SUNDRY NOTICES AND REPORTS ON WELLS (DO NOT USE THIS FORM FOR PROPOSALS TO DRILL OR TO DEEPEN OR PLUG BACK TO A DIFFERENT RESERVOIR. USE "APPLICATION FOR PERMIT" (FORM C-101) FOR SUCH PROPOSALS.)		WELL API NO. 30-041-20600

2. Name of Operator POCO RESOURCES		6. State Oil & Gas Lease No. V-23
3. Address of Operator 3307 E. CASTLEBERRY ROAD, ARTESIA, NM 88210		7. Lease Name or Unit Agreement Name STATE

This is a request to P&A the subject well. The planned procedure is below, the current and proposed wellbore diagram is attached for reference.

Action 475168

POCO Resources LLC (373121) - PROPOSED PA
State #001
API No. 30-041-20600

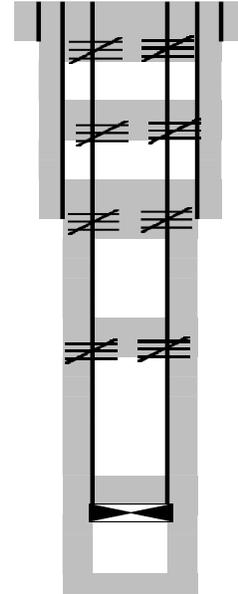
Cut & cap wellhead.
Perf @ 500', sqz 150sx Cl C cmt to surface. WOC. Verify cmt to surface. RDMO.

Perf @ 2868', sqz 115sx cl C cmt to 2238'. WOC. Tag.

Perf @ 4258', sqz 70sx Cl C cmt to 4082'. WOC. Tag.

Perf @ 5546', sqz 35sx Cl C cmt to 5446'. WOC. Tag.

RIH & set CIBP @ 9477'. Pump 25sx Cl H cmt on top. WOC, tag.

Created By	Condition	Condition Date
loren.diede	Notify the OCD inspection supervisor via email 24 hours prior to beginning Plug & Abandon (P&A) operations.	6/23/2025
loren.diede	NOTE: When perfring to squeeze cement behing casing, NMOCD requires that the perfs be located 50' BELOW the formation top and cement placed at least 50' ABOVE formation top. This is in reference to the proposed perfs for the Glorietta and Yates/Rustler plugs.	6/23/2025
loren.diede	Submit the CBL tif file to NMOCD. loren.diede@emnrd.nm.gov.	6/23/2025
loren.diede	Add a plug to cover the Abo formation top with a plug from 7752' to at least 7652'. NMOCD requires that there be no more than 3000' between plugs, this Abo plug satisfies that requirement.	6/23/2025
loren.diede	NMOCD has determined that this well is within the LPCH restricted area and therefore a below ground P&A marker is required.	6/23/2025
loren.diede	Submit a photo and GPS coordinates of the P&A marker with the subsequent P&A reports and submission.	6/23/2025
